Item P9 - Attachment 1 - Report 20 July 2005

TITLE: [PD] Development Application DA05/0195 for a Residential Flat Building 6 Storeys Comprising of 12 Units and Two Levels of Underground Car Parking at Lot C DP 406494 No. 2 Boundary Lane and Lot 1 DP 350710, No. 4 Boundary Lane, Tweed Heads

FILE NO: DA05/0195 Pt1

SEAN GARTNER ARCHITECTS		NEW APARTMENTS 2-4 BOUNDARY LANE, TWEED HEADS		Client: J&S Project Number: 0430 Date: FEB 2013	
22.00.00	A	DEVELOPMENT APPLICATION	DATE: 2013	SCALE: 1:1000	FIG. NO: A-06	SHEET: 11 OF 12	
				ELEVATIONS - NW, SW & SE

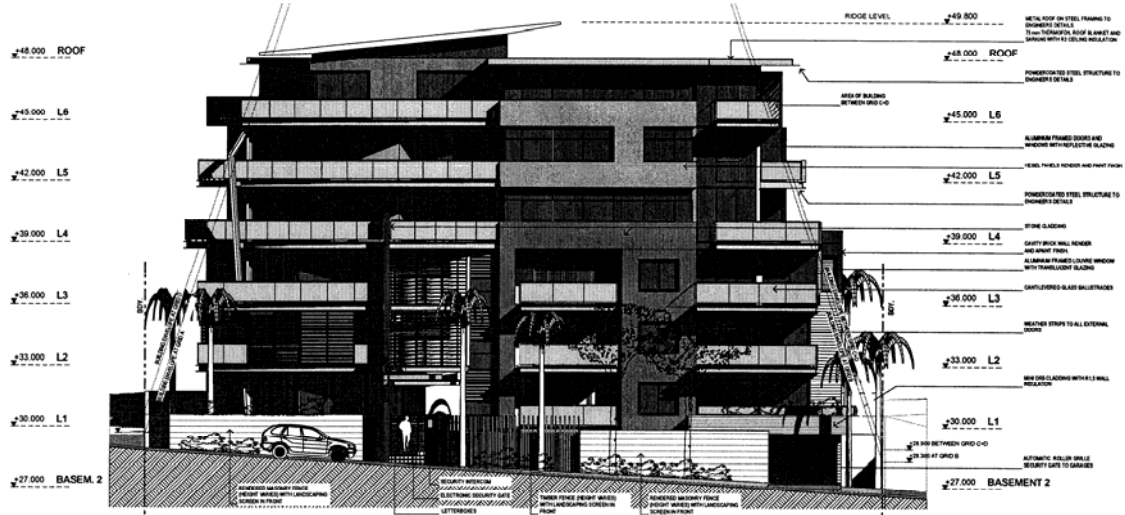
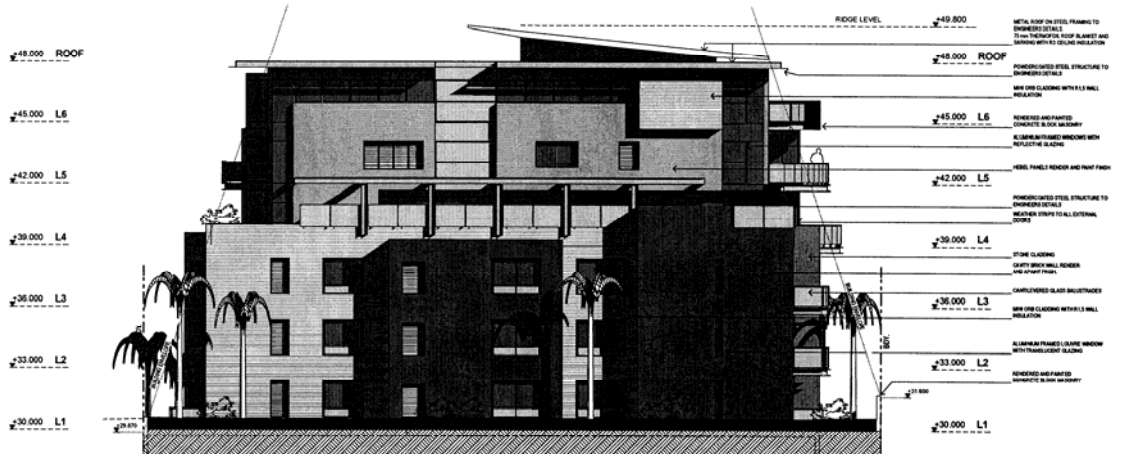
From the plans submitted the proposal has extremely minor areas of walls, and small areas of open decks that encroach the envelope. The minor encroachments for open balconies generally occur at levels 4, 5 and 6 while the minor wall encroachments occur at levels 2 and 3 on the southern side.

The applicant has submitted that the encroachments are minor and are equalised by not utilising other areas of available building envelope. It is further noted that the difference between the proposal and a fully complying building envelope would not result in any significant change to shadow impact.

Having regard to the slope and shape of the site it is considered that the proposal represents a sensible and well-balanced approach to the building envelope control. Furthermore, the development complies with intent of the planning controls with the bulk of the building falling within the building height plane. Considering the minor nature of the encroachments and the benefit the building obtains in articulation as a result, a variation to the Building Height Plane is supported in this particular instance.

SEAN GARTNER ARCHITECTS		Project: NEW APARTMENTS 2-4 BOUNDARY LANE, TWEED HEADS Client: [Redacted] Date: 11/20/2018		Sheet: 0430 Title: 1:300 - SALL Date: 11/20/2018	
						Drawing: SHADOW DIAGR. - WINTER/SUMMER Scale: A-08 Rev: A

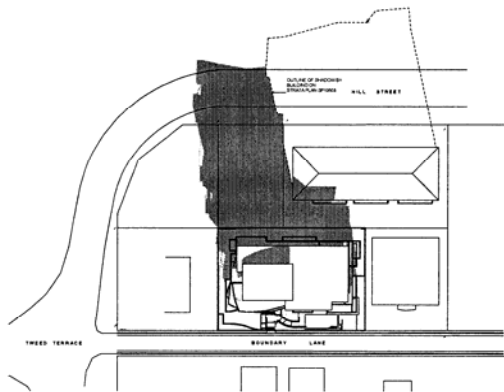
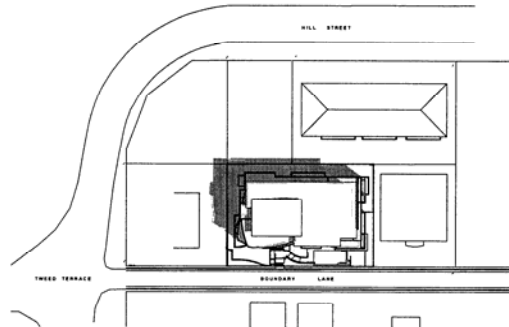
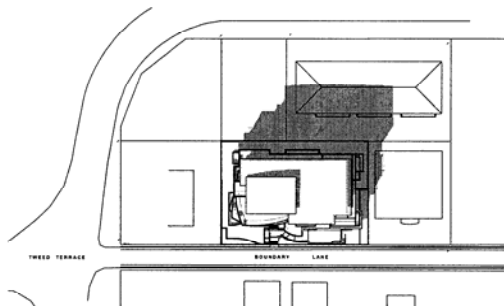
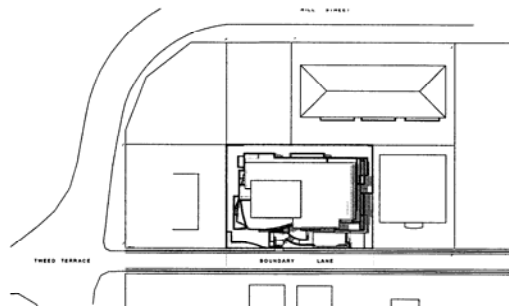
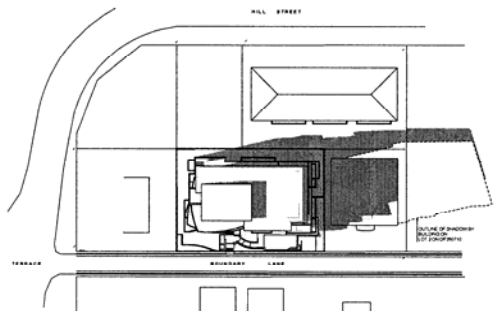
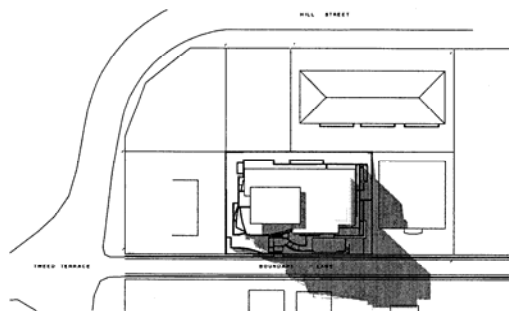
OBJECTION	IMPACT ASSESSMENT
<i>A variation to the DCP having regard to privacy and overshadowing should not be supported.</i>	Council's Development Control Plans are outcomes based and provide numerical specifications for guidance and in some instances strict compliances. As detailed in the above report the proposed variations are considered minor and do not warrant amendment or refusal of this application.
<i>The DA should have been accompanied with as shadow diagram as</i>	Shadow diagrams accompanied the application to assist in the assessment of the application. As detailed in the above report the implications from shadow are considered not to adversely
